SITE 53 SYDNEY OLYMPIC PARK

SECTION 4.55 MODIFICATION (SSD 7662 Mod 1)

RESPONSES TO DPE COMMENTS

SOP 53
2 FIGTREE DRIVE
SYDNEY OLYMPIC PARK

DESIGN - FENCE

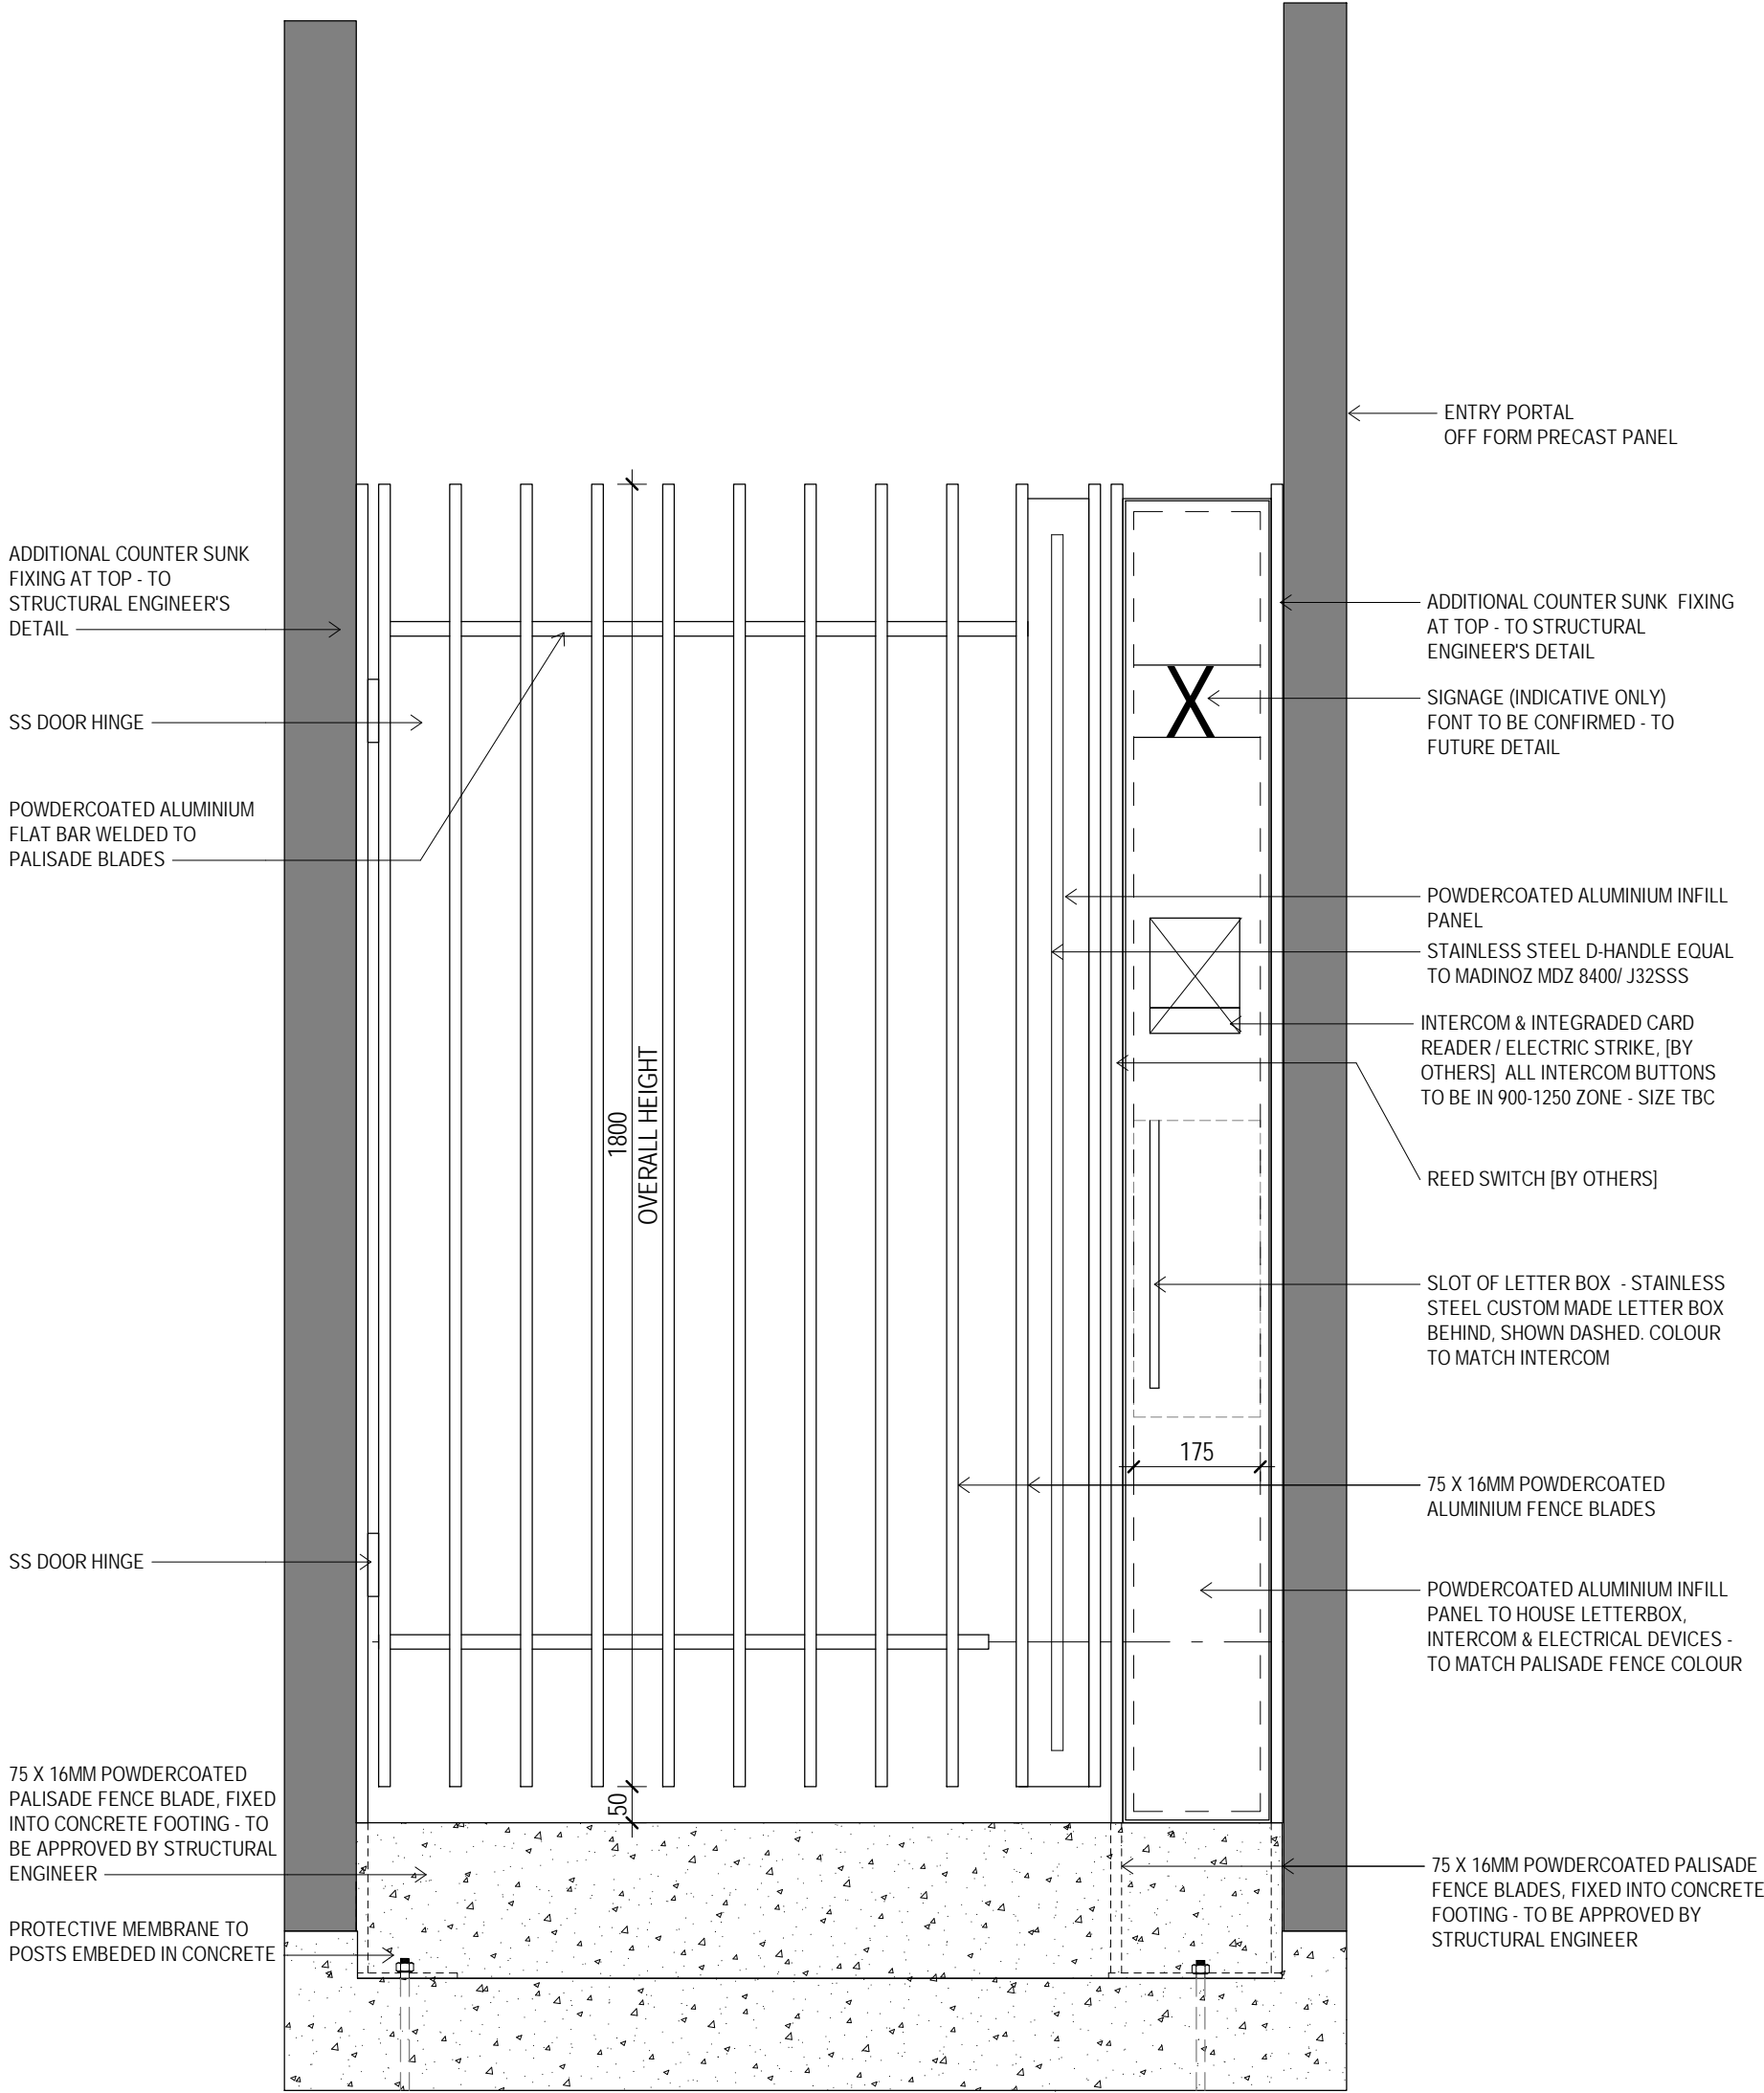
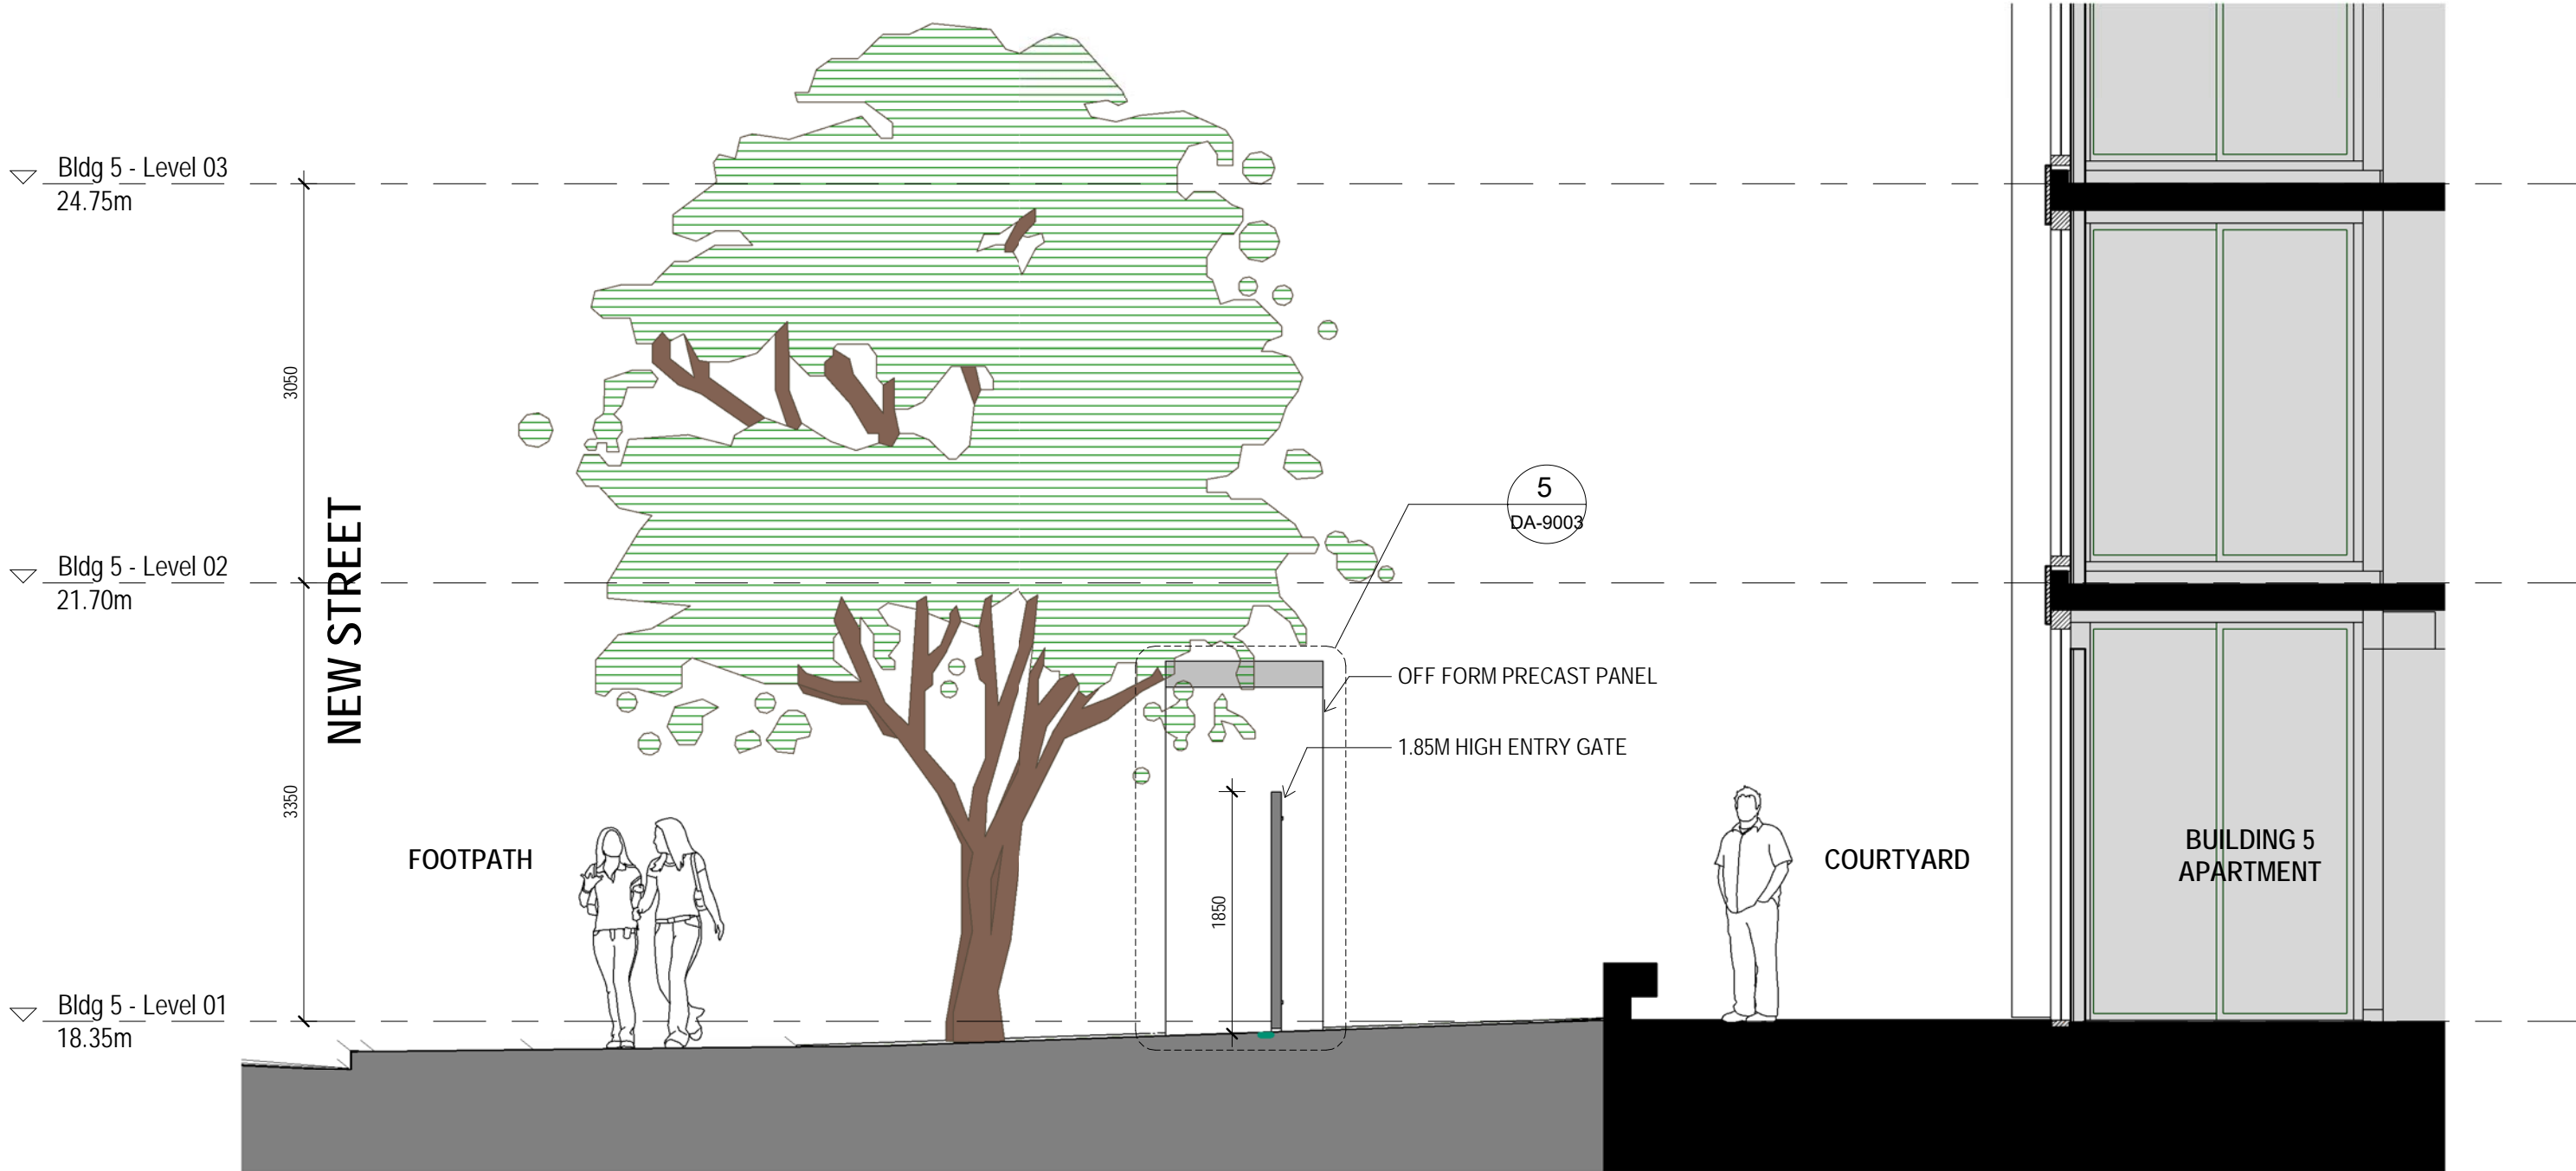
PROVIDE JUSTIFICATION FOR THE INCREASED FENCE HEIGHT AND CHANGE IN MATERIALS TO THE GROUND FLOOR UNIT ENTRANCES

ENTRY PORTAL IS PROVIDED TO THE GROUND FLOOR UNITS IN BUILDING 5 FOR DIRECT STREET ACCESS . AS PART OF THE DESIGN DEVELOPMENT PROCESS, THE FENCE IS STEPPED TO FOLLOW THE SLOPED FOOTPATH AND THE HEIGHT IS ADJUSTED TO ALIGN WITH THE GATE FOR PRIVACY & SECURITY REASON.

EACH ENTRY PORTAL IS FINISHED WITH OFF FORM PRECAST CONCRETE AND THE GATE & FENCE ARE IN SAME MATERIAL FOR CONSISTENCY AND FINISHED IN POWDERCOATED ALUMINIUM.
